PROJECT TITLE
**British Museum
 Perimeter Properties Refurbishment**

DRAWING TITLE
**No.8 - No.11 Montague Street
 Proposed Series
 Plan
 Basement Level 1 of 2
 Listed Building Consent Application**

DRAWING NO.
(20)AP007

REVISION
Rev B

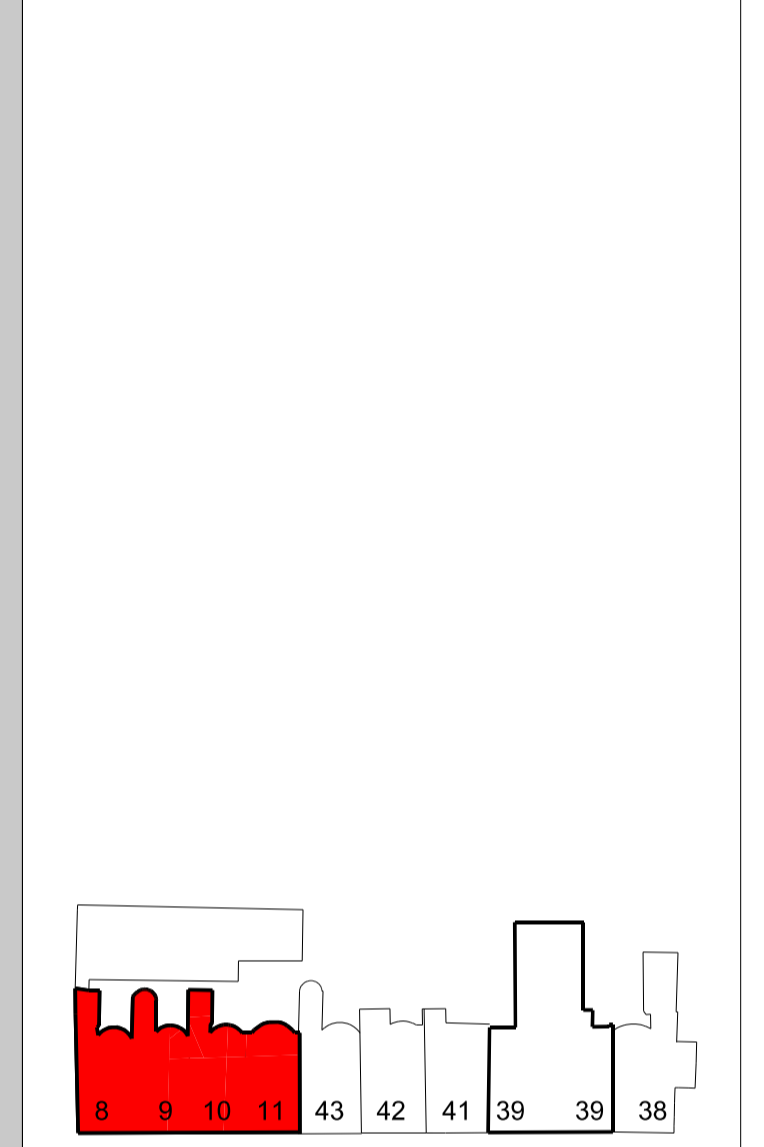
REVISION DESCRIPTION	DRAWN	CHECKED	DATE
Listed Building Consent Application			03/11/16
<ul style="list-style-type: none"> - Existing floors levelled with latex screed - Location of new service risers identified - New ceilings installed in toilet, 200mm approx. lower than existing ceilings prior to work commencing on site - Partitions removed to reinstated lightwell 10MS/1/002. Rear external doors fitted to store 10MS/1/006 and lobby 10MS/1/001 - Revised toilet layout to 9MS/1/005 to incorporate additional WC - Revised toilet layout to 10MS/1/007 to incorporate new step to accommodate access to raised floor level - New timber sash windows B.01.W03, B.01.W09, B.01.W13 to match existing - New lobby door in 8MS/1/002 - Additional access doors B.02.D00 to Office 11MS/1/001 and B.02.D02 underneath stairs for storage access - New cupboards with butler sink in Office 11MS/1/001 - Relocation of radiators in 9MS/1/001 from underneath window to adjacent wall due to service pipes being unable to travel across the opening of door B.02.D14 - Existing openings in party walls between properties 9MS & 10MS and 10MS & 11MS enclosed with fire protected panels to avoid major works should there be a requirement to relocate openings at a later stage - New external lighting in front yards and rear lightwells

Listed Building Consent Application - Rev B			18/11/16
<ul style="list-style-type: none"> - External lighting in front yards removed
